RE: Letter of Justification for Administrative Approval of Façade Changes

WYNDHAM RENOVATIONS
 RHINO INVESTMENTS
 NM HOTEL LLC
 2500 CARLISLE BLVD NE
 ALBUQUERQUE, NM 87110

ADMINISTRATIVE AMENDMENT

SITE PLAN PROPOSED USES

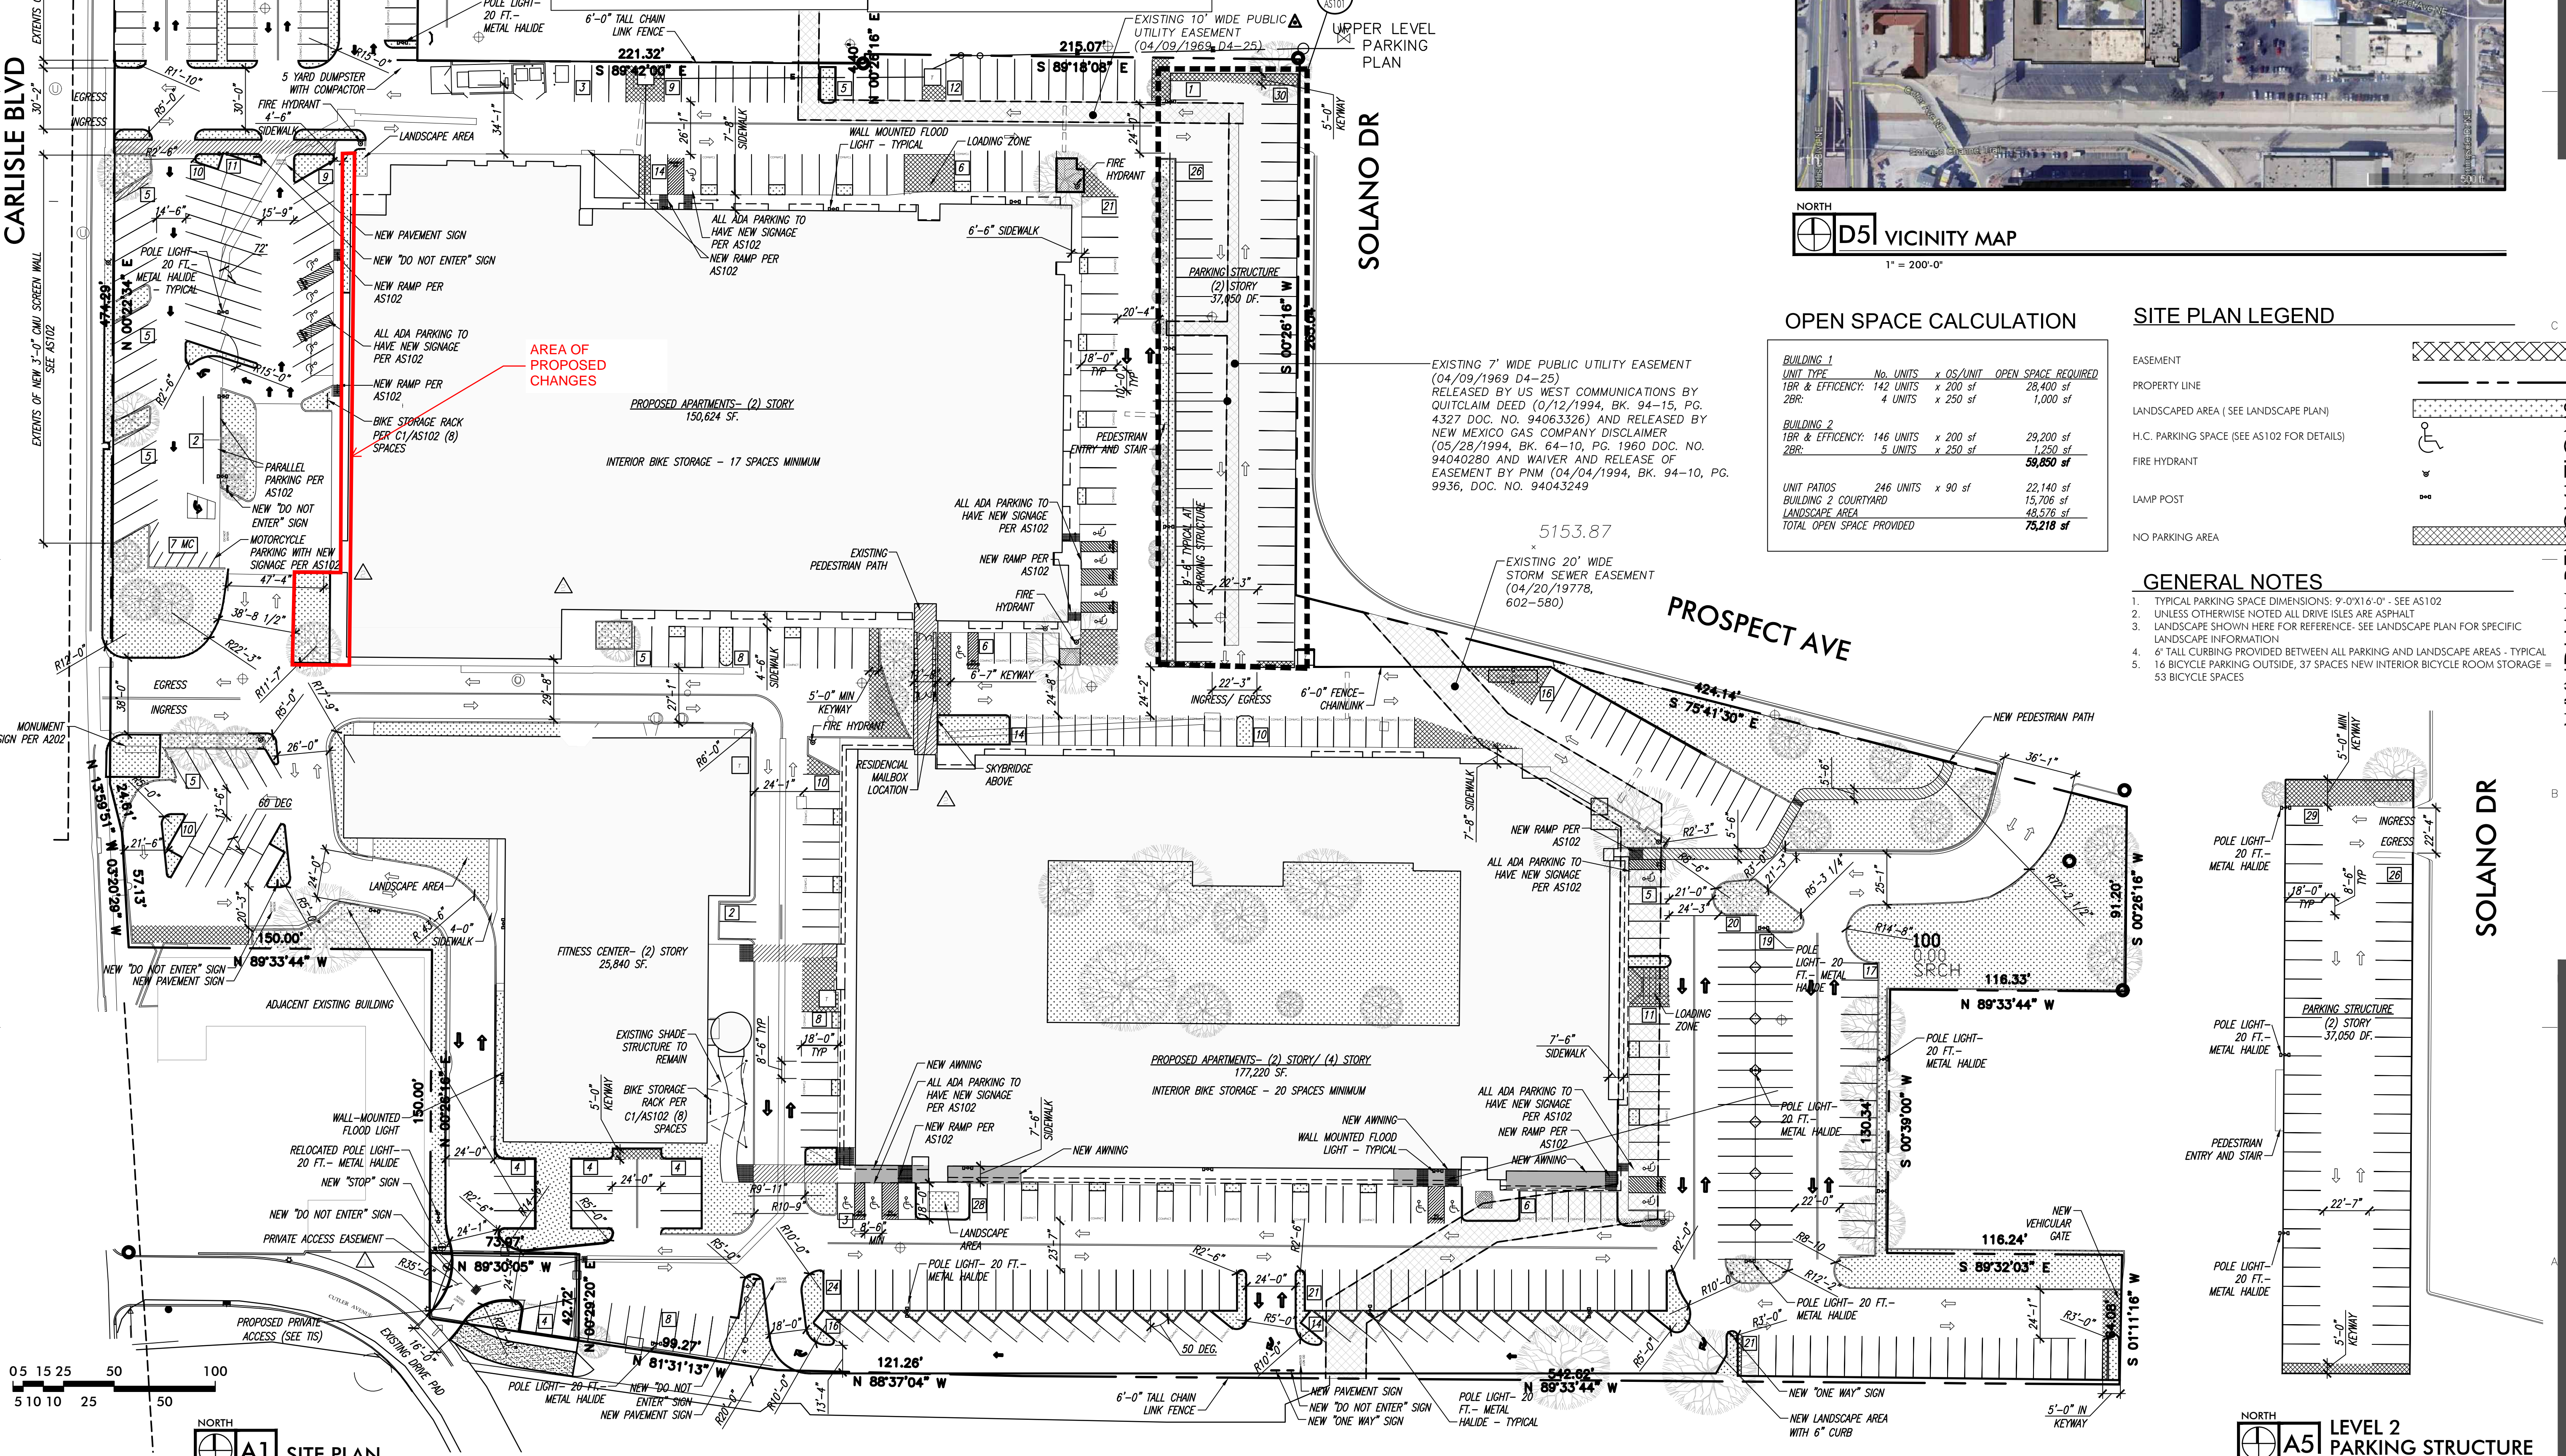
PROPOSED CHANGES - SEE ELEVATION FOR LOCATION

POWER AND LOCATION FOR FUTURE LIGHTED SIGNS - TO BE PERMITTED SEPARATELY

NEW COLOR COAT OVER EXISTING STUCCO SYSTEM - COLOR 1

NEW COLOR COAT OVER EXISTING STUCCO SYSTEM - COLOR 2

NEW PAINT FINISH OVER EXISTING FACADE RELIEF PANELS

NEW METAL FACADE PANELS AT NORTH AND SOUTH END OF FACADE

NEW NICHHA SIDING OVER EXISTING STUCCO SYSTEM

NEW STOREFRONT

REPLACE EXISTING PLANTERS WITH NEW PLANTERS

NEW LIGHTED BOLLARDS AT SIDEWALK

A1 PROPOSED WEST FACADE

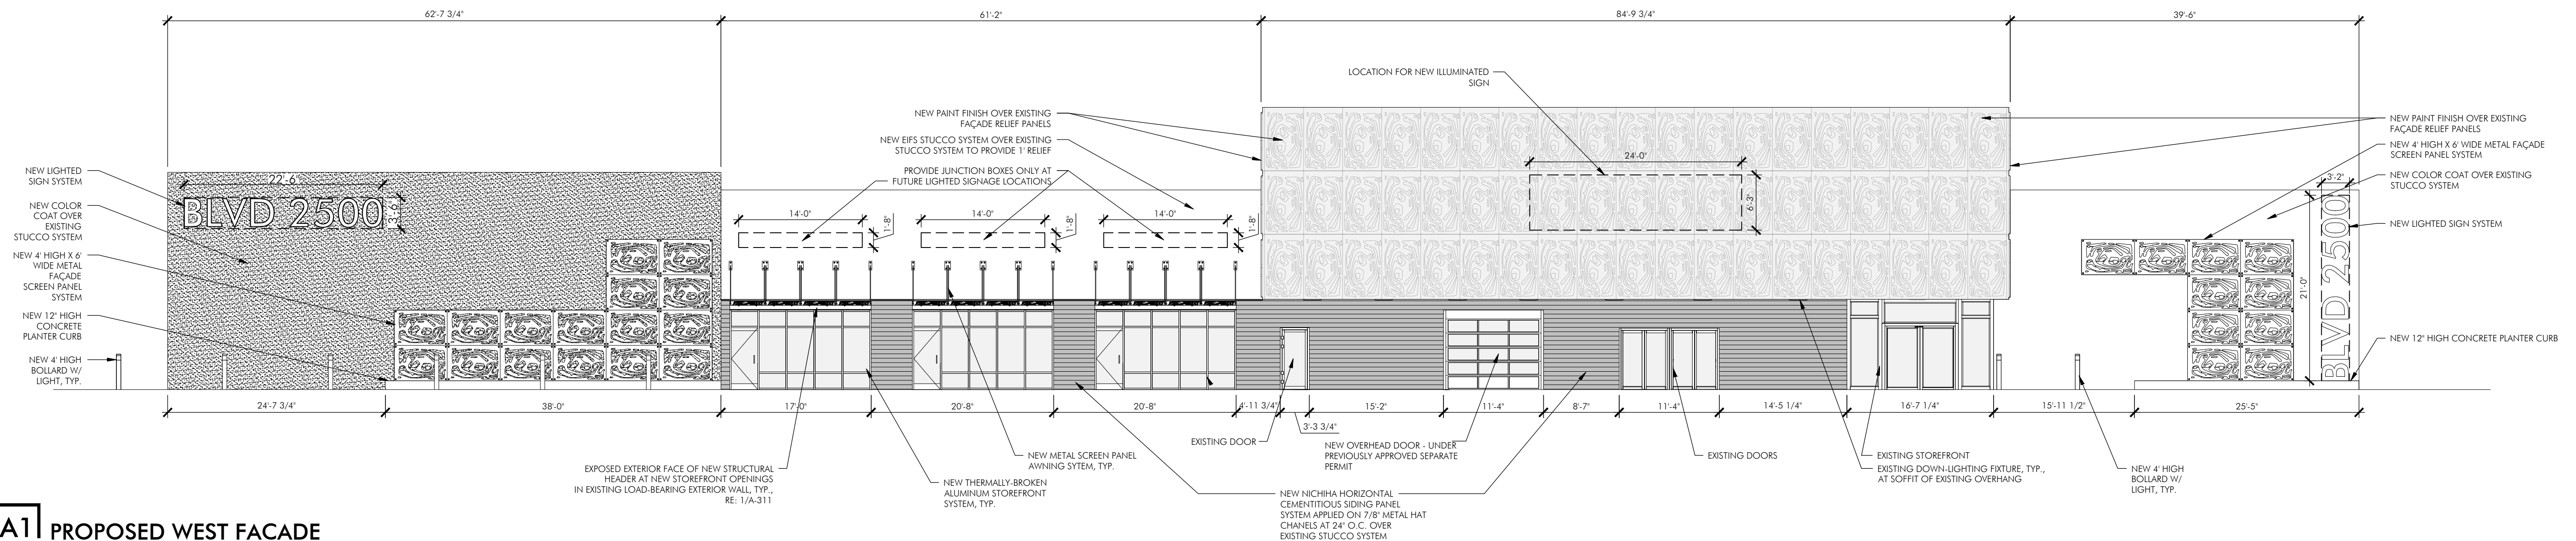
POWER AND LOCATION FOR FUTURE LIGHTED SIGNS - TO BE PERMITTED SEPARATELY

- NEW COLOR COAT OVER EXISTING STUCCO SYSTEM - COLOR 1 
- NEW COLOR COAT OVER EXISTING STUCCO SYSTEM - COLOR 2 
- NEW PAINT FINISH OVER EXISTING FACADE RELIEF PANELS 
- NEW METAL FACADE PANELS AT NORTH AND SOUTH END OF FACADE 
- NEW NICHHA SIDING OVER EXISTING STUCCO SYSTEM

NEW STOREFRONT
 REPLACE EXISTING PLANTERS WITH NEW PLANTERS
 NEW LIGHTED BOLLARDS AT SIDEWALK
